SITE PLAN CHECKLIST

3. NAME OF THE PROJECT/BUSINESS.
CRIBS WAREHOUSE
4. SCALE AND NORTH ARROW.
AS SHOWN ON PLANS.
5. PROPERTY LINES WITH DIMENSIONS AND PROPERTY AREA.
AS SHOWN ON PLANS. AREA = 1.92 ACRES OR 83,451.0 SF MORE OR
LESS.

PROJECT NO. SD231009	
REVISIONS	BY DATE DESCRIPTION
NO.	1 1/3/25 PER CITY REVIEW
EHRHART GRIFFIN & ASSOCIATES 601 N. Minnesota Ave. Sioux Falls, So. Dak. 57104 P: 605 / 339-7215 F: 605 / 339-7271 • ENGINEERING • PLANNING • LAND SURVEYING	
HOH WAREHOUSE SITE & LANDSCAPING PLAN LOT 4, BLOCK 6, BAKKER LANDING 1ST ADDITION TEA, SD 57064	
DATE: 01/13/25 DESIGNED BY: MAS DRAWN BY: MAS CHECKED BY: DFG CREW: LRM	
PROGRESS SET NOT FOR CONSTRUCTION	
SHEET NO. C-104

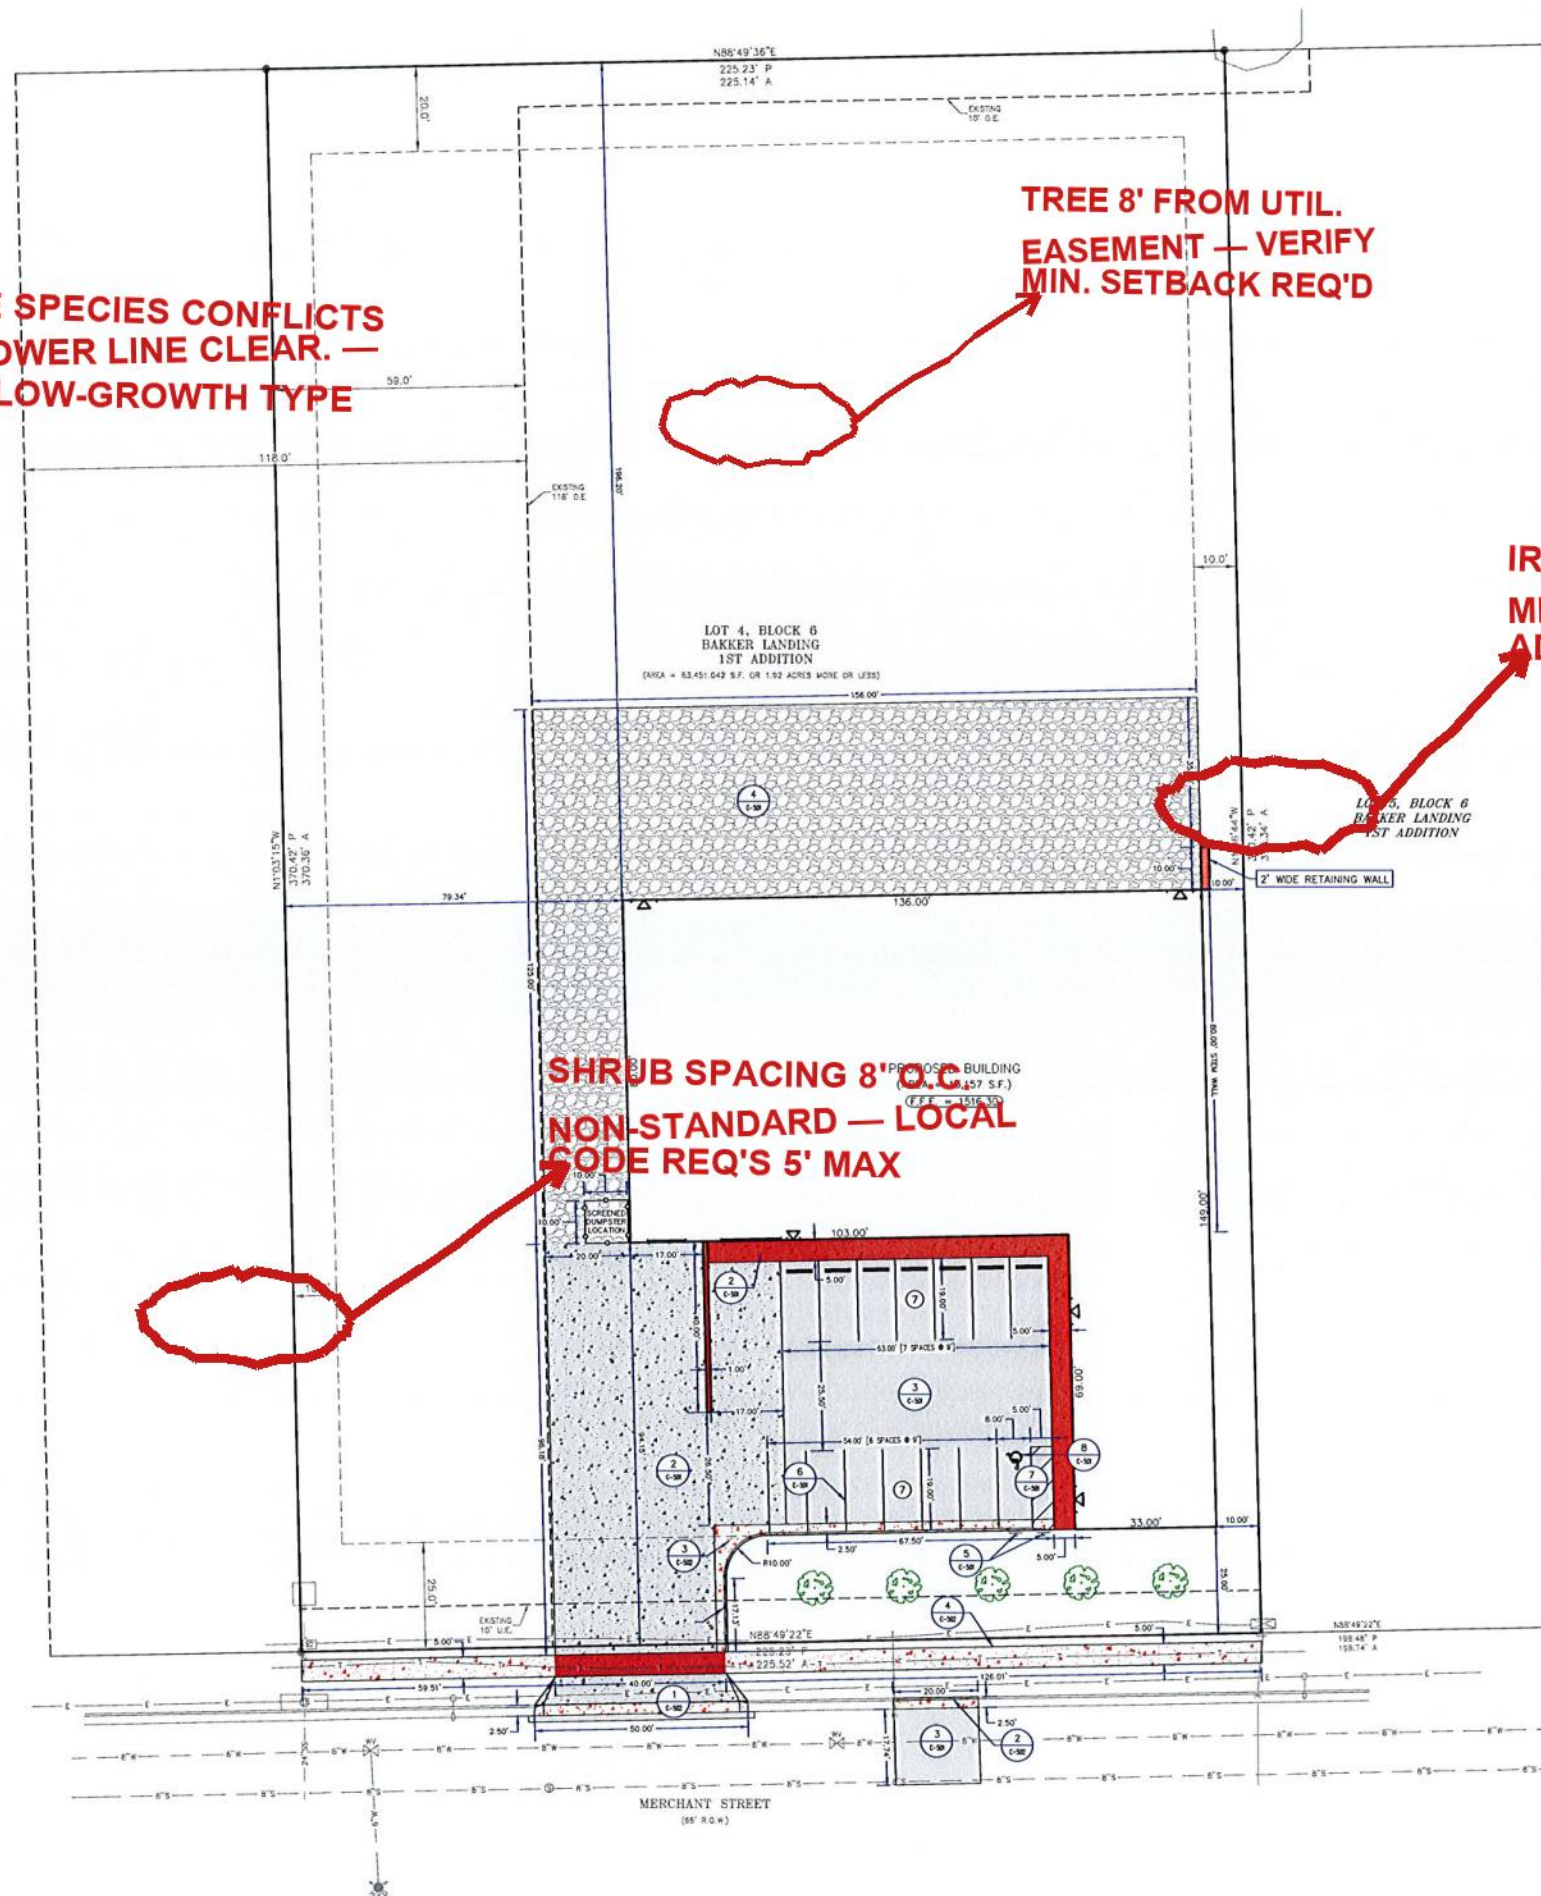
TREE SPECIES CONFLICTS
W/ POWER LINE CLEAR. —
USE LOW-GROWTH TYPE

TREE 8' FROM UTIL.
EASEMENT — VERIFY
MIN. SETBACK REQ'D

IRRIGATION COVERAGE
MISSING AT E CORNER —
ADD ZONE OR HEADS

SHRUB SPACING 8' O.C.
NON-STANDARD — LOCAL
CODE REQ'S 5' MAX

GROUND COVER TYPE
NOT SPECIFIED AT
BORENTENTION AREA
